We have finished reviewing the stormwater plans and report and the proposed system meets our rules and requirements. Before the Water Resources Review of your building permit can be completed and approved the following items must be completed:

**From:** Hansen, Brian <[bhansen@BloomingtonMN.gov](mailto:bhansen@BloomingtonMN.gov)>  
**Sent:** Tuesday, April 20, 2021 3:14 PM  
**To:** PJ Disch <[PDisch@loucksinc.com](mailto:PDisch@loucksinc.com)>  
**Subject:** 8131 34th Ave - Stormwater Questions

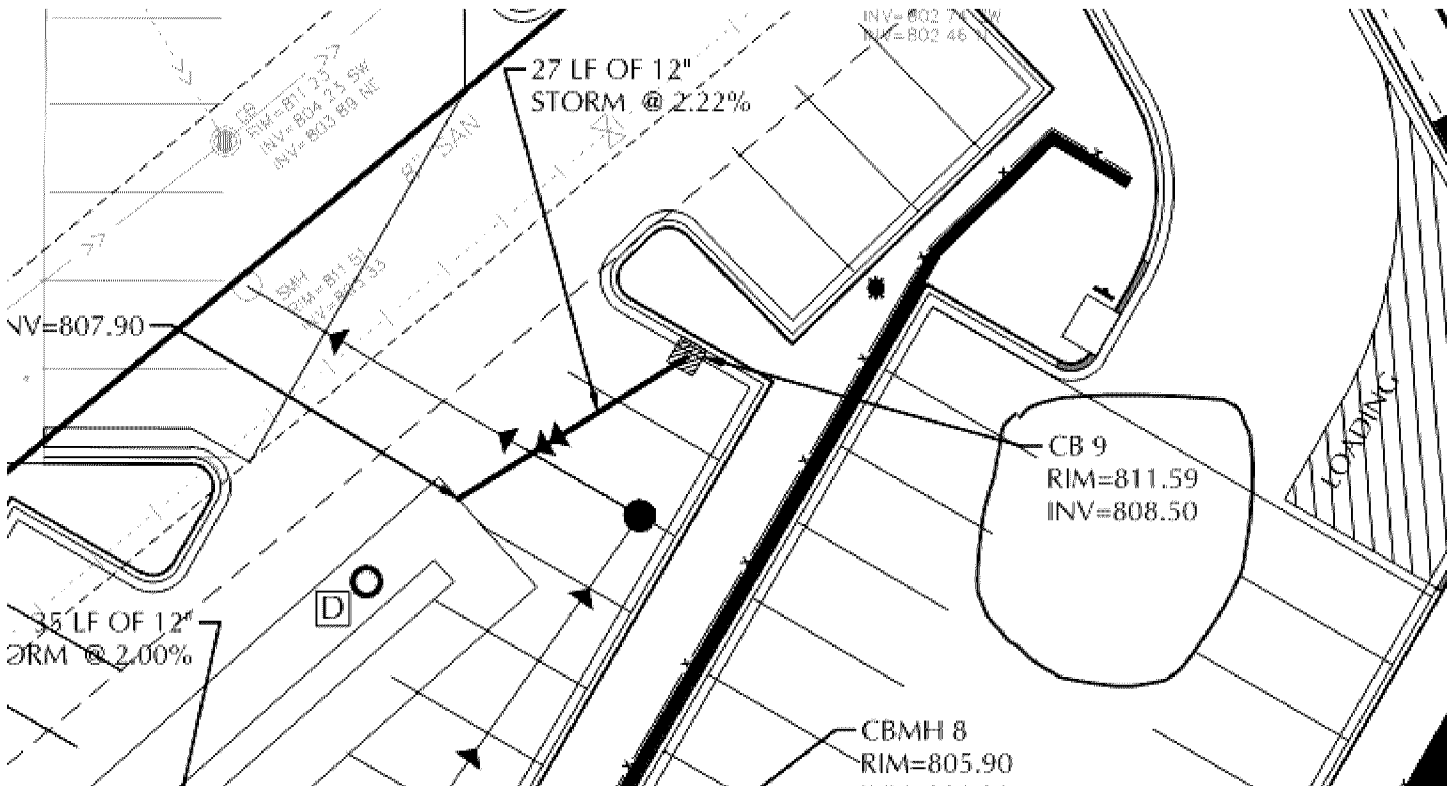
Just following up with you on this e-mail. We acknowledge the challenges with this site as they relate to stormwater management. At our last meeting with our Water Resources Staff some potential alternative techniques were proposed such as the Stormtech system. The ultimate solution may include a combination of strategies that best fit the site.

We still would recommend maximizing the amount of runoff that can get into the infiltration chambers and gravity flow out to 34<sup>th</sup>, any additional would need to be pumped.

Some strategies that may be worth exploring are:

1. moving the watermain, which would give another 13' to work with
2. raising the elevation of the roof drains, which should get all of the building footprint into the system

It continues to be the City's desire to abandon the in-place storm pipe that outlets over the bluff. If you were to utilize this 60+ year old pipe for your site we would need to first determine it's condition and then an easement agreement between the development and the USF&W would need to be acquired to allow you to discharge over the bluff and maintain the pipe in it's current location. This process could be very lengthy based on previous experience working with USF&W on similar projects/requests.

We have been digging into this some. The system you called out stormtech has a volume of 5,740 for retention volume. We need volume for stormwater bounce as well. The CMP system we have has a total volume of 17,000 cf for the treatment volume and bounce to control the runoff rate. The stormtech system only has the treatment volumes, so we will not have the volume to control the runoff rate.

Also we have CB 9 which is the runoff from the parking lot that has a rim of 811.39 which is lower than the proposed invert of 812.8 which you are calling out for our outlet connection.
